UNITED STATES PATENT AND TRADEMARK OFFICE

Office Action Summary

10/679,758

DETAILED ACTION

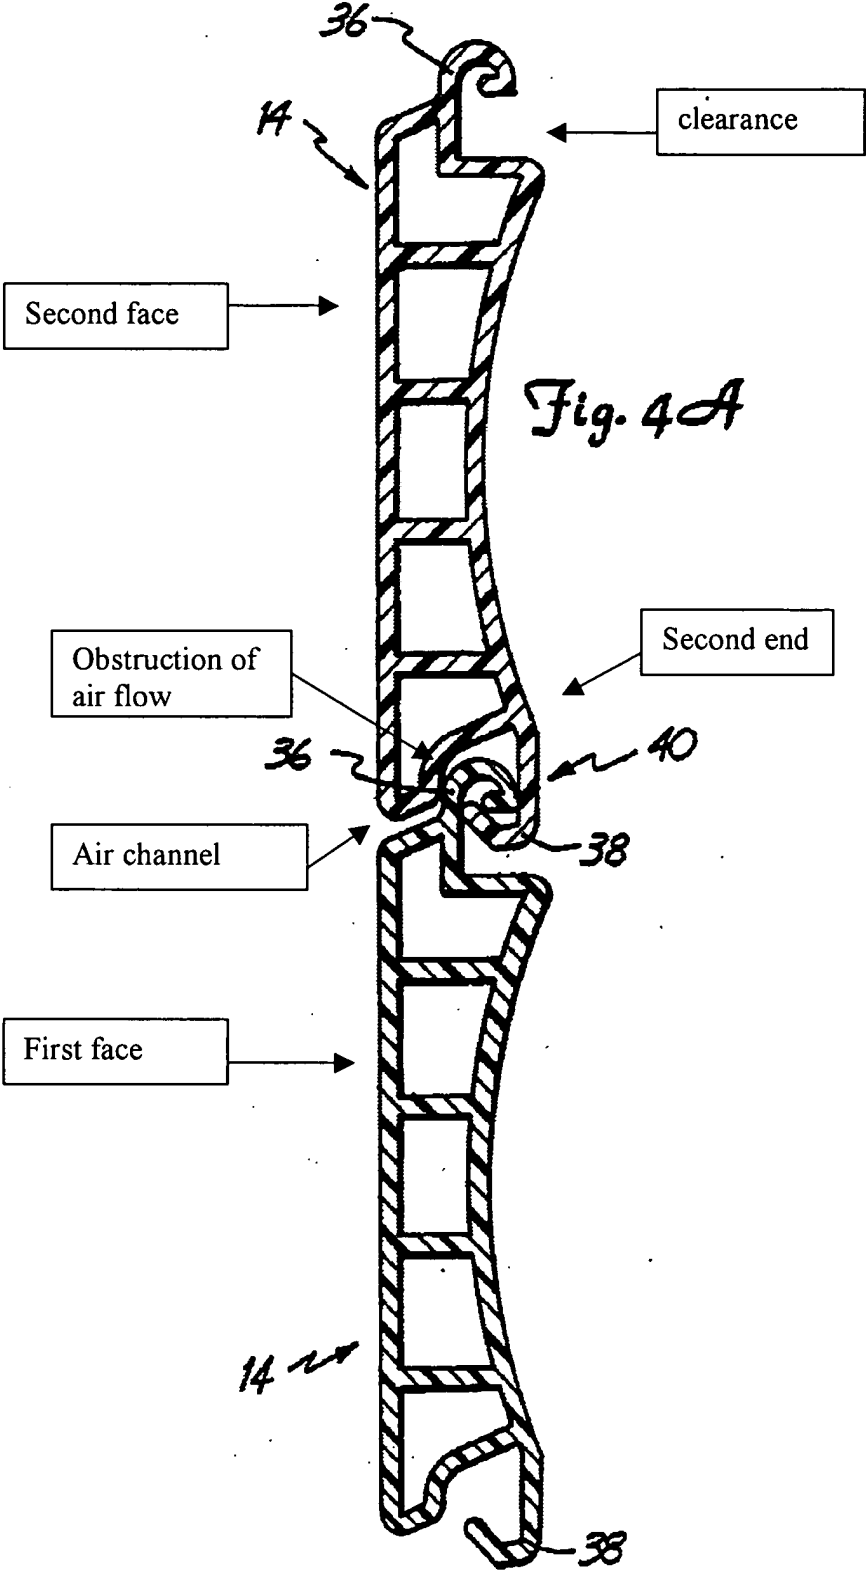
Regarding claim 1, Teigen et al. disclose a door (12) for use with a vehicle (10), the vehicle defining a load space (15) and having an access opening (16) communicating between the load space (15) and atmosphere, the door (12) comprising: a first panel (14) having an end (36), the end (36) having an arm and a protuberance connected to the arm (Fig. 4A), together the end, the arm, and the protuberance defining an arcuately shaped recess (Fig. 4A); and a second panel (14) having a hook (38), the hook being engageable (Fig. 4A) in the arcuately shaped recess to pivotably connect the first panel and the second panel, the hook having an arcuate shape corresponding to the arcuately shaped recess.

Regarding claim 2, Tiegen et al. disclose the door of claim 1, wherein the first panel has a first face (see below) and the second panel has a second face (see below), and wherein the second panel is pivotable relative to the first panel between a first orientation (Fig. 4B), in which the second face is substantially perpendicular to the first face (although Fig. 4B does not show the panel completely pivoted so that the second face is perpendicular to the first face, the panels are capable of such orientation), and a second orientation (Fig. 4A), in which the second face is substantially parallel to the first face.

Regarding claim 3, Tiegen et al. disclose the door of claim 2, wherein the second panel is fixedly connected to the first panel when the second panel is in the second orientation (Fig. 4A) and wherein the second panel is removeably connected to the first panel when the second panel is in the first orientation (when the panels are in the first orientation the hook would be able to fit through the clearance (see below) of the recess (36) and therefore would be removeably connected).

Regarding claim 6, Tiegen et al. disclose the door of claim 1, wherein the first panel and the second panel (14) define an air channel between the load space (15) and the atmosphere, the hook (38) matingly engaging the protuberance (36), and together, the protuberance and the hook obstructing air flow through the air channel (see below).
